# PRODUCT / PROCESS CHANGE NOTIFICATION

| 1.2 PCN No.          | EMBEDDED PROCESSING/26/16266                                                                                                                   |
| 1.3 Title of PCN     | HTXA (China) additional UFQFPN5x5 32L and UFQFPN7x7 48L package assembly line for STM32G03x/G04x, STM32G05x/G07x and STM32G08x listed products |

### PCN16266 – Additional information

**Table 1**

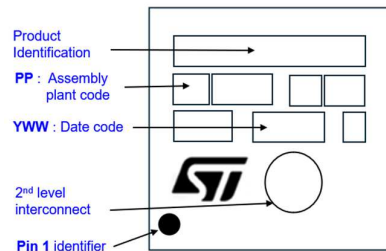
Introduction of an additional assembly line to continue our path through the deployment of our Low-cost wire strategy to secure our supply chain.

Changes are described in table below:

The standard marking fields example below  
for **UFQFPN 32L 5X5** package

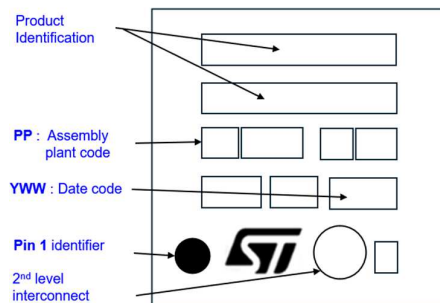
Pin1 identifier may change in terms of size and positioning however remaining near pin1's edge.  
Marking position and size may be different upon assembly site, without any loss of information.
